ADDENDUM No. 1

ITB No. 4668

BARTON, ARGO, AND SUPERIOR GATE REPAIR

ANCHOR BOLT REPLACEMENT
NOT TO SCALE

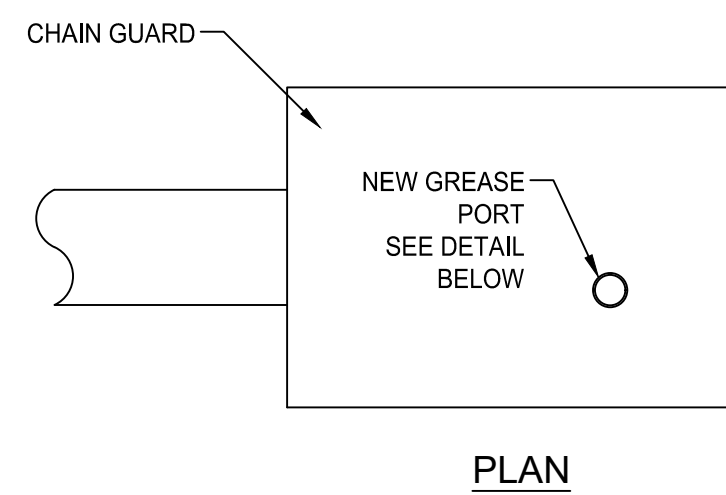
- Question 3: Item #37 Replace Hoist Anchor Bolts: please provide a detail for how you would like the anchor bolts replaced. If the hoists are not being removed, is there a modified anchor bolt detail that will allow bolt installation without having to remove the hoists?

- Answer 3: Sheet G-002 includes the anchor bolt replacement detail. The existing bolts should be cored out and replaced with new bolts, with the machine base still in place.

1. REMOVE AND REPLACE GROUT BASE - USE SPEC CHEM SC MULTI-PURPOSE GROUT.
2. CORE OUT EXISTING ANCHOR BOLTS PER ADHESIVE MANUFACTURER RECOMMENDATIONS
3. INSTALL NEW 3/8" THREADED ROD (F1554 gr. 105, GALVANIZED), 9" MIN. EMBED INTO WALL (BELOW BOTTOM OF GROUT).
4. GROUT ANCHOR USING HILTI HIT-RE-500 V3 ADHESIVE, OR APPROVED EQUAL. INSTALL ANCHOR SYSTEM PER MANUFACTURER RECOMMENDATION.

GREASE PORT DETAIL
NOT TO SCALE

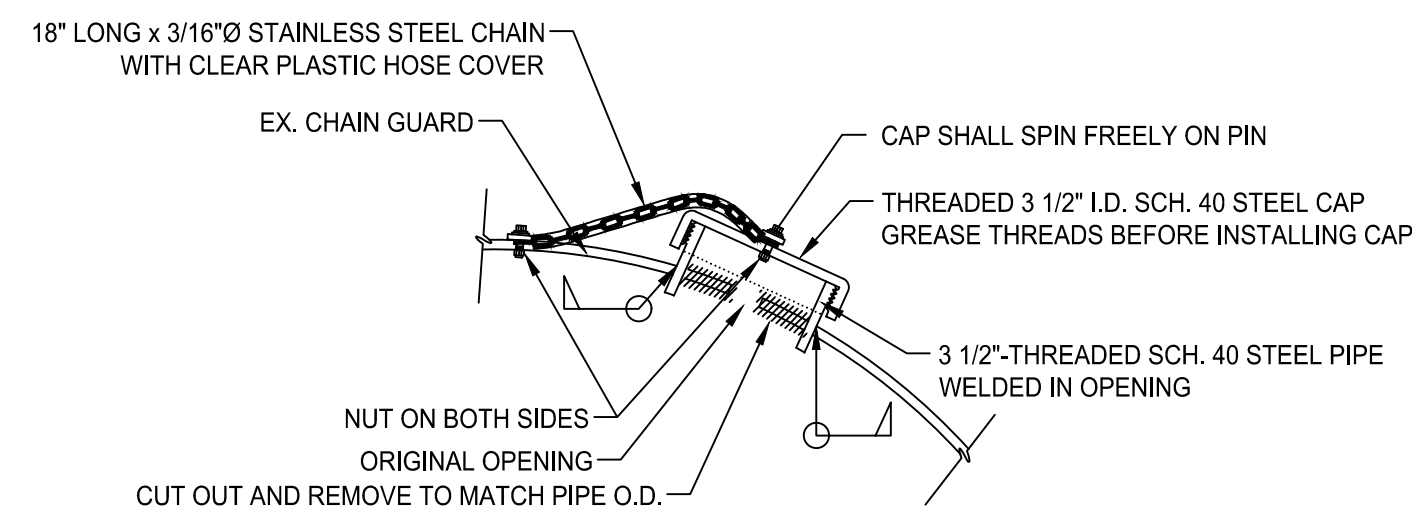
G-002

Add:

GREASE PORT DETAIL

<u>ITEM</u>	<u>ITEM IN PROPOSAL</u>	<u>METHOD OF MEASUREMENT</u>	<u>BASIS OF PAYMENT</u>
36A	Add Grease Ports	By the unit (EA)	Manufacturer grease port cap, install port onto chain guard
42A	Add Grease Ports	By the unit (EA)	Manufacturer grease port cap, install port onto chain guard

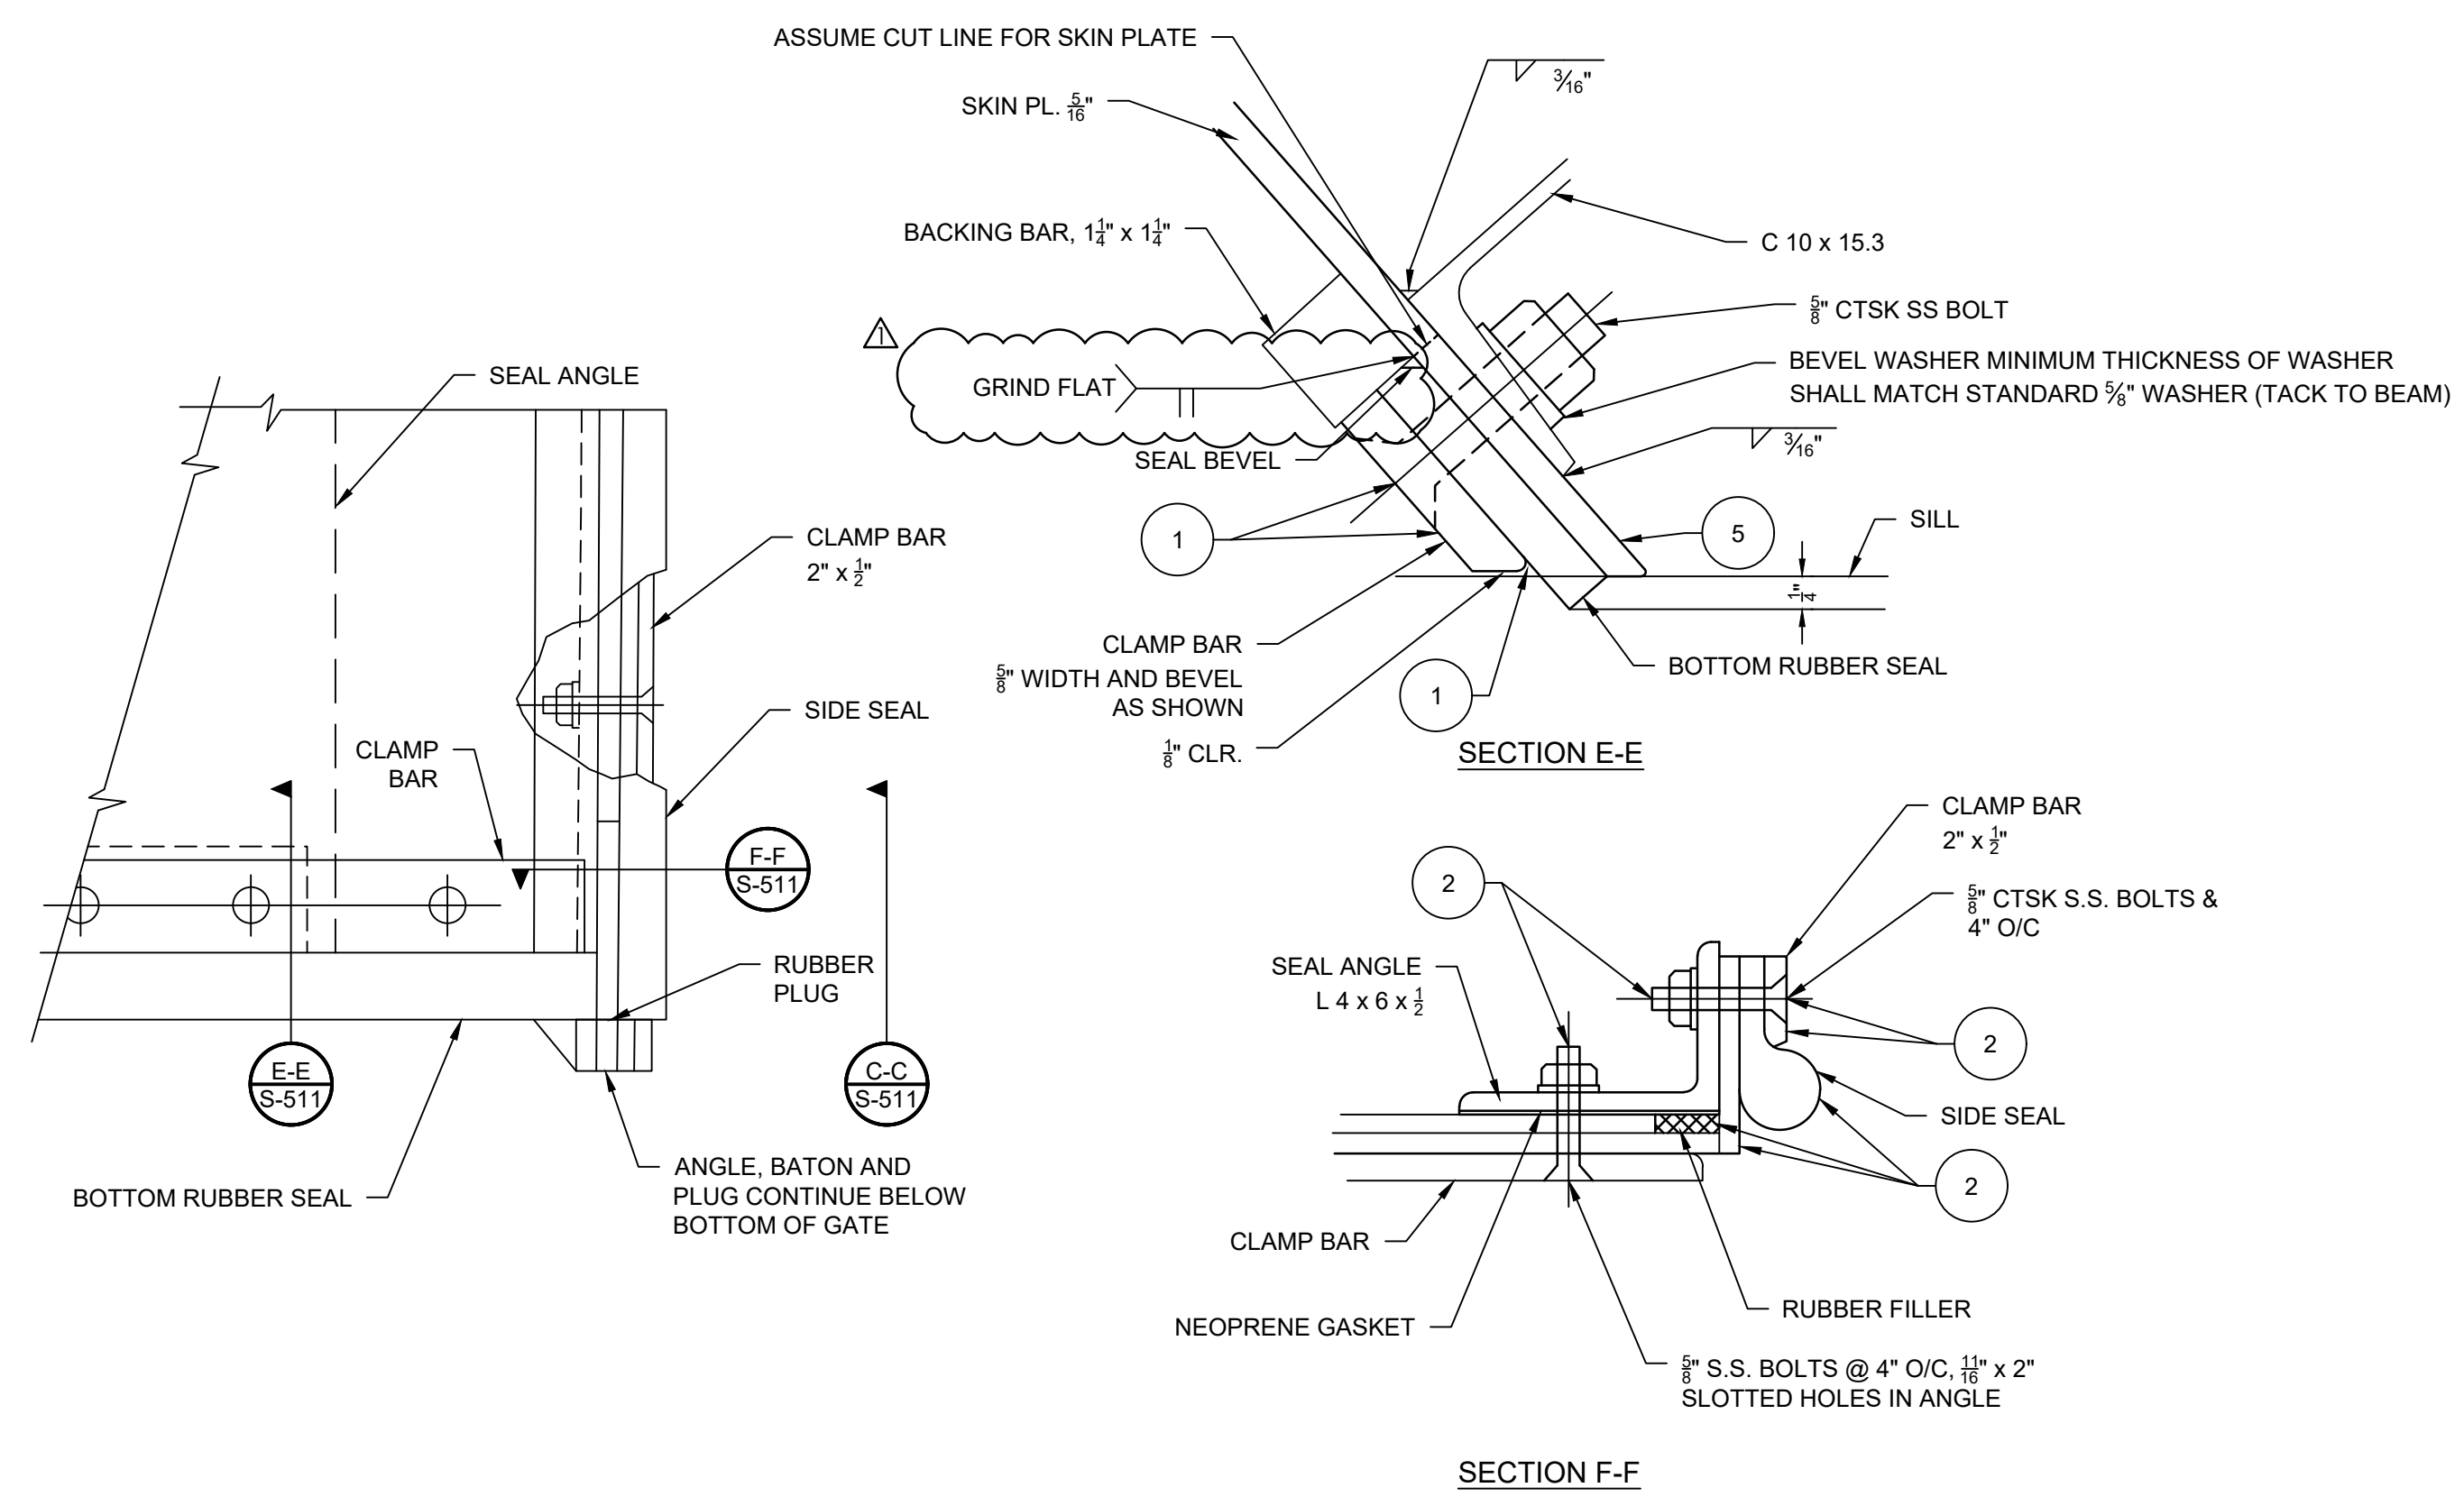
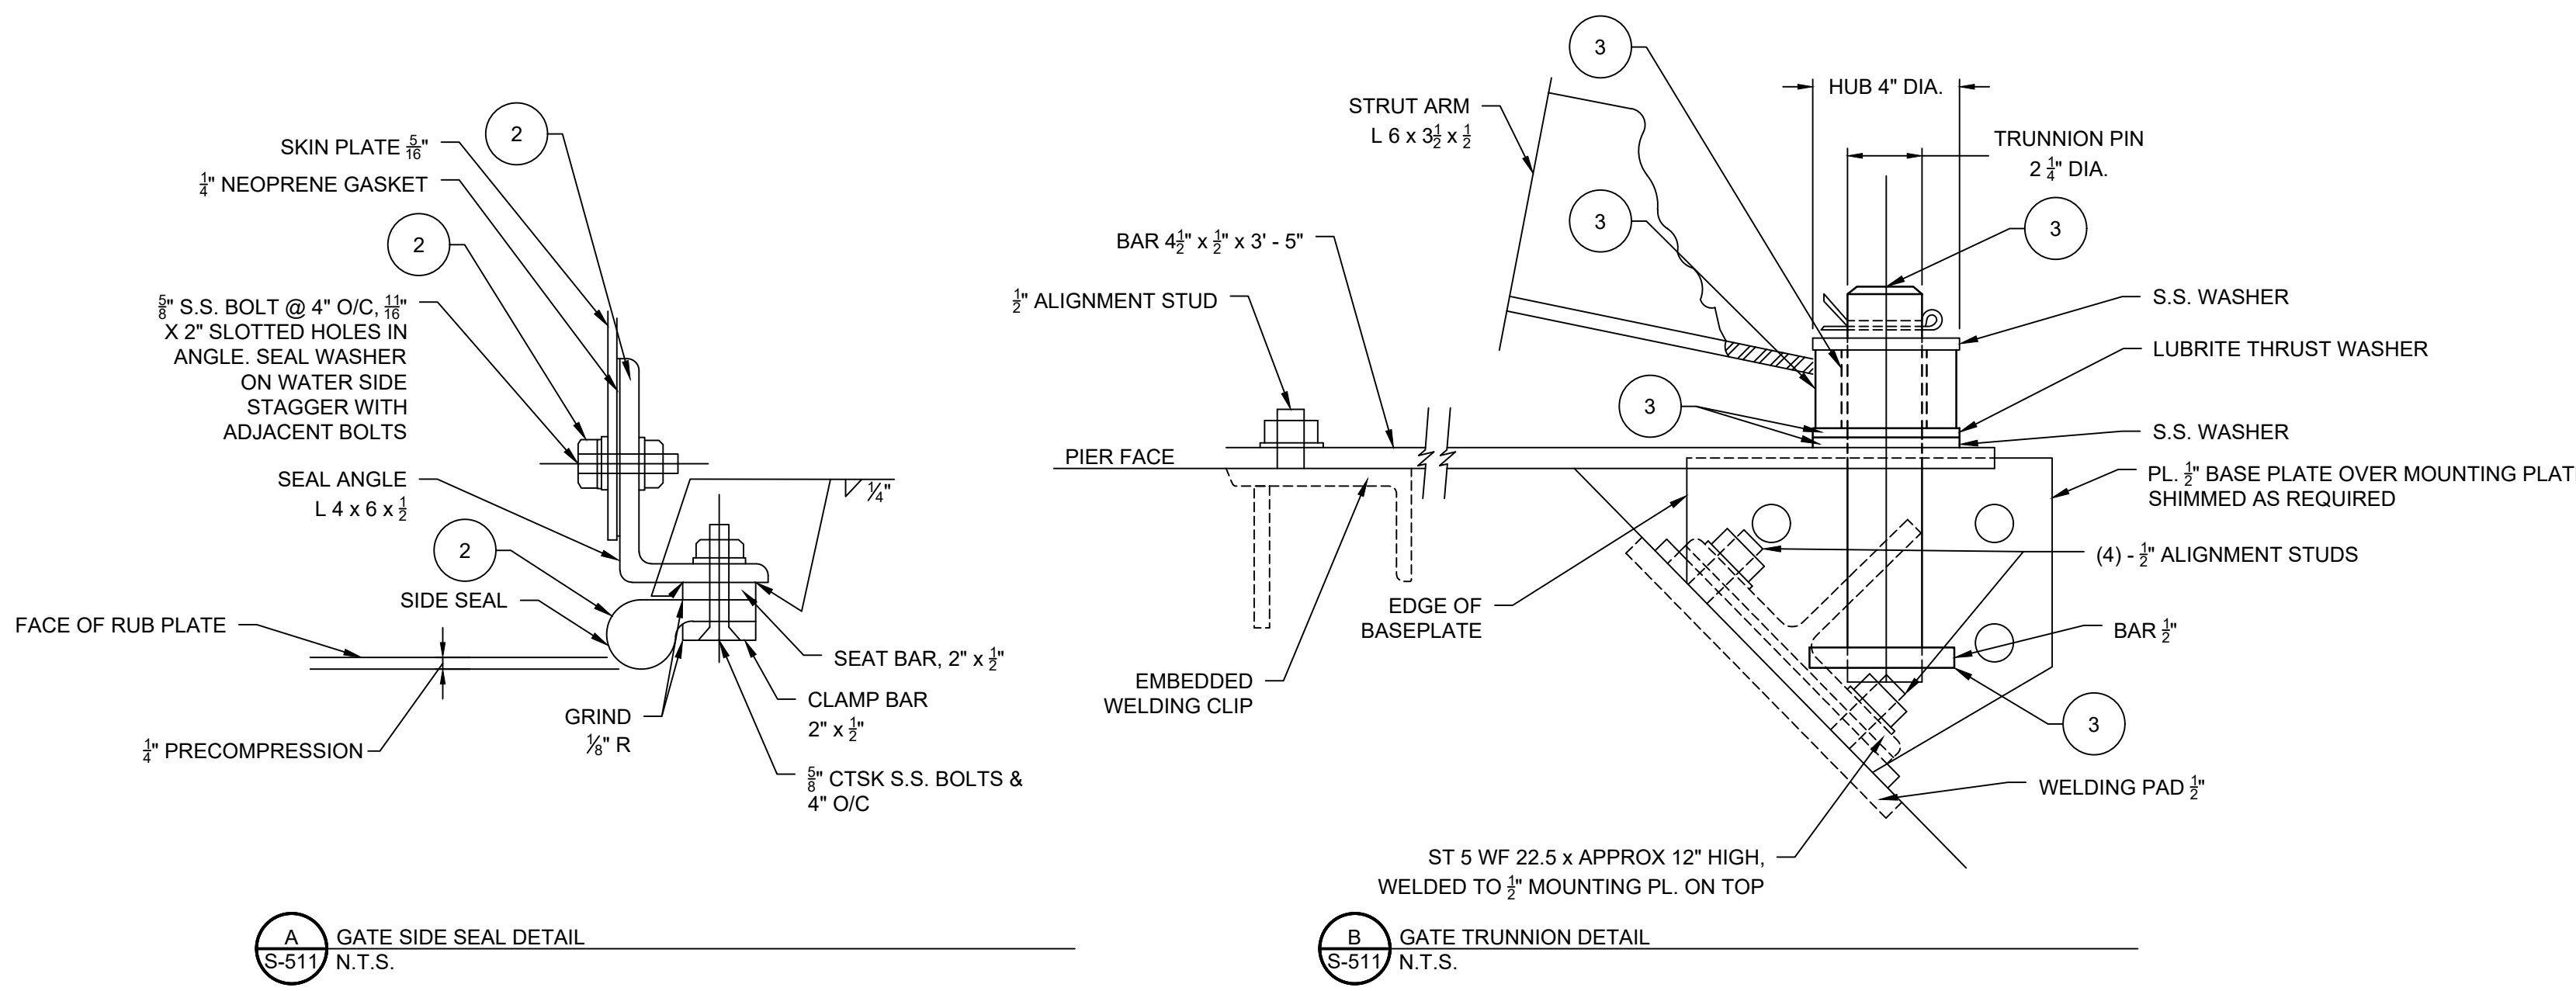
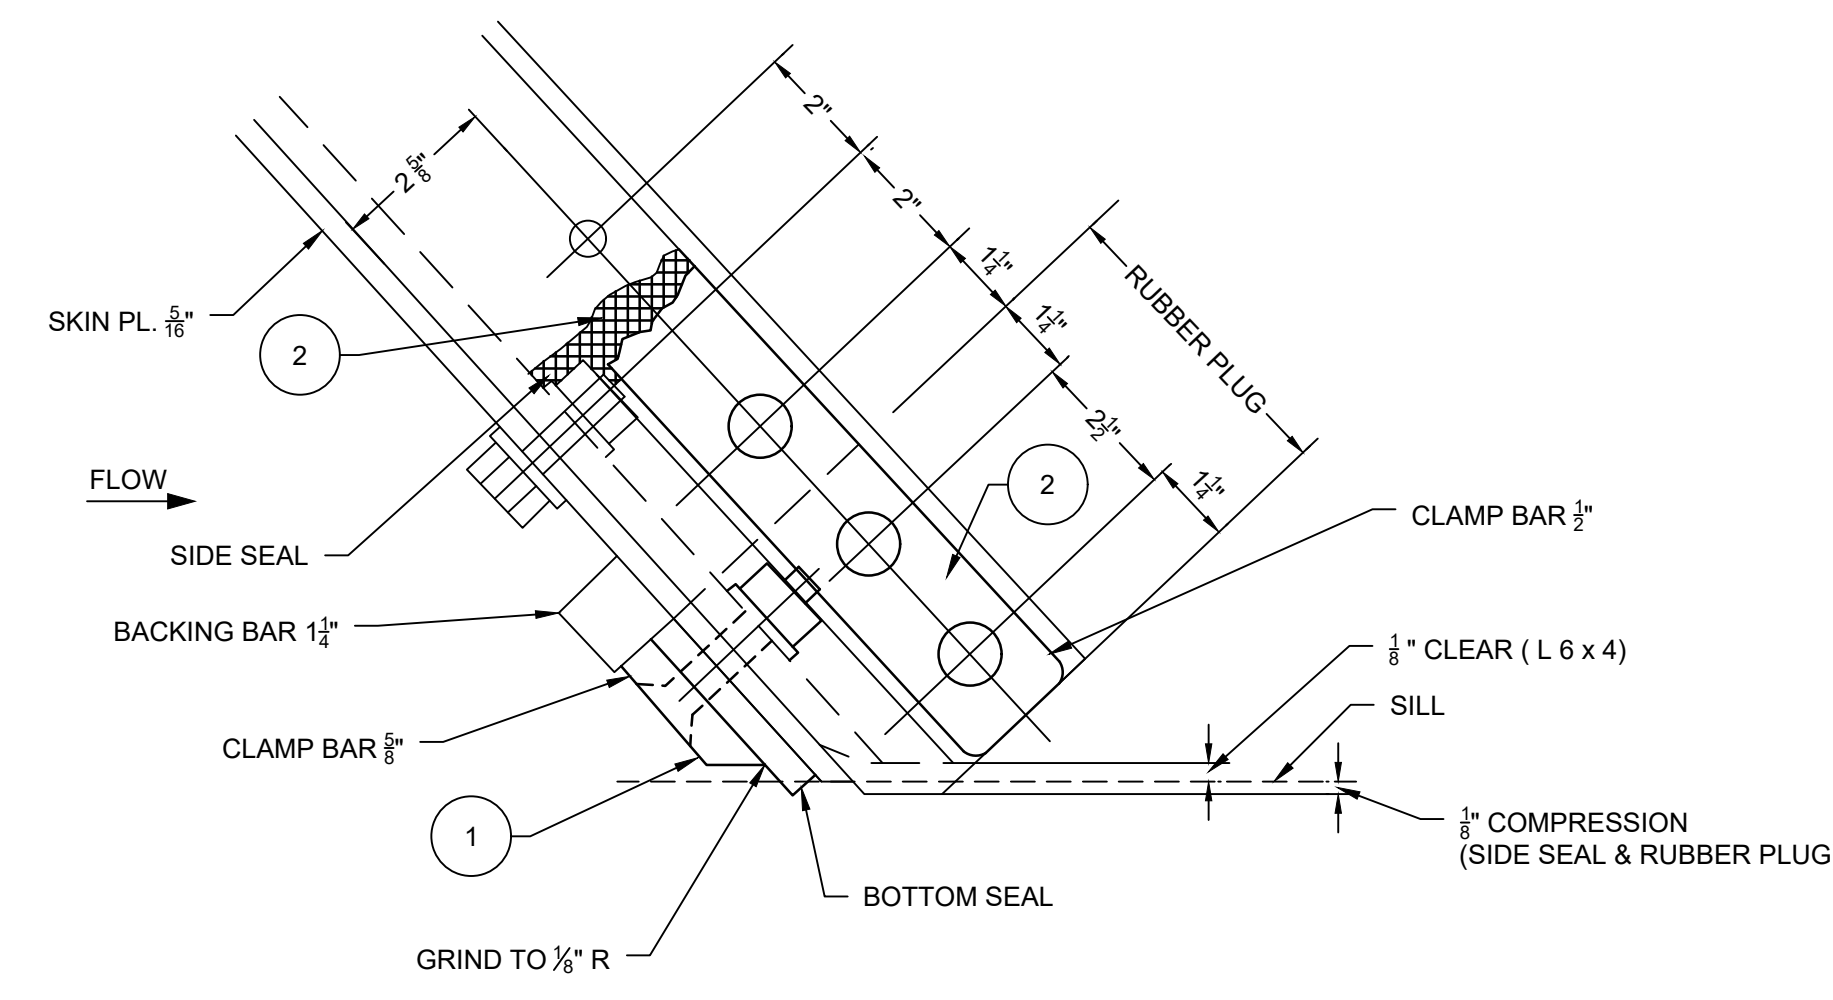
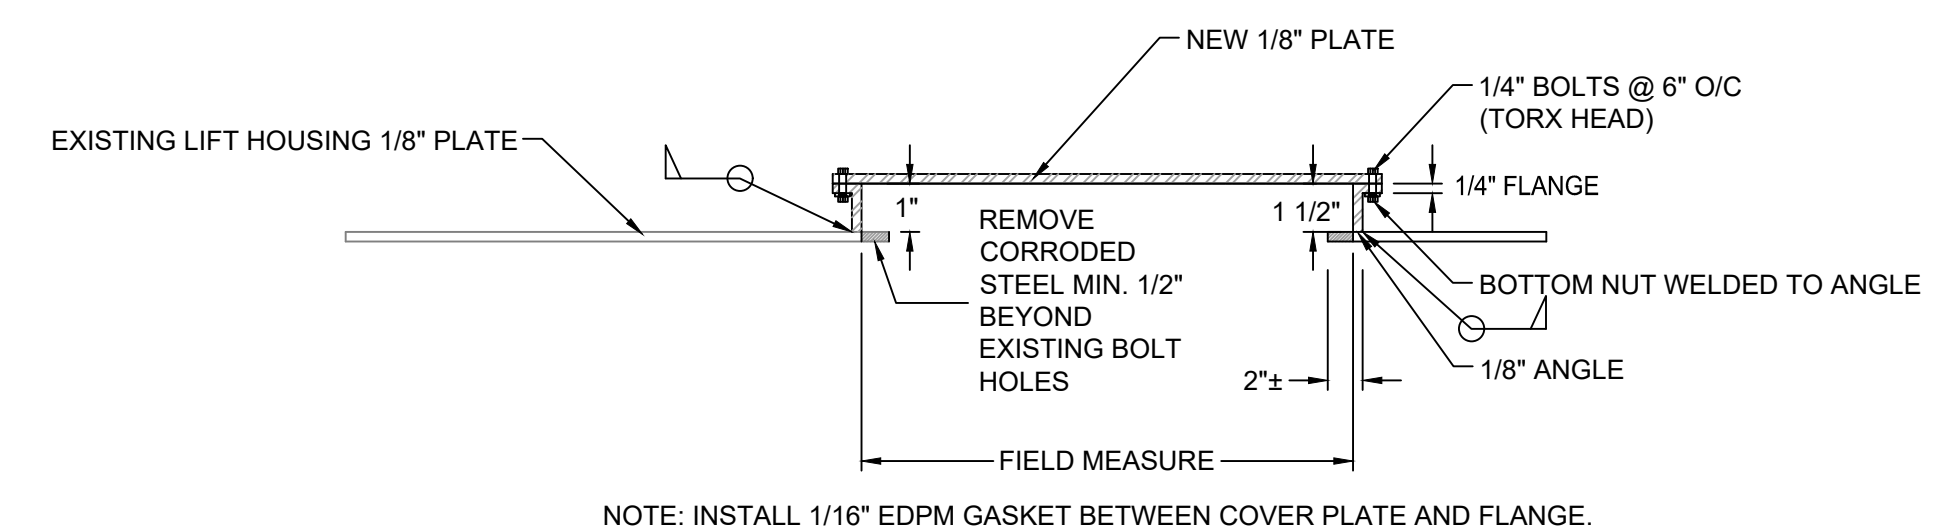
S-511

Add:

Weld callout on Section E-E

- Question 5: Item #39 Bottom Edge Skin Plate Replacement: Is the only weld required located at the edge of the channel flange, as shown in section EE on page S-511?

- Answer 5: An additional weld was added at the joint. The updated sheet has been added to the drawing set.
- Question 6: Item #40 Replace Trunnion Pin and Bushing: Please clarify what is being replaced. For Barton, the spec book indicates there is concrete work, and we are only replacing Pins and Bushings which appears to be different than what's shown on S-511. Is the intent to replace everything that is bolted to concrete? Are any anchor bolts or alignment studs being replaced?
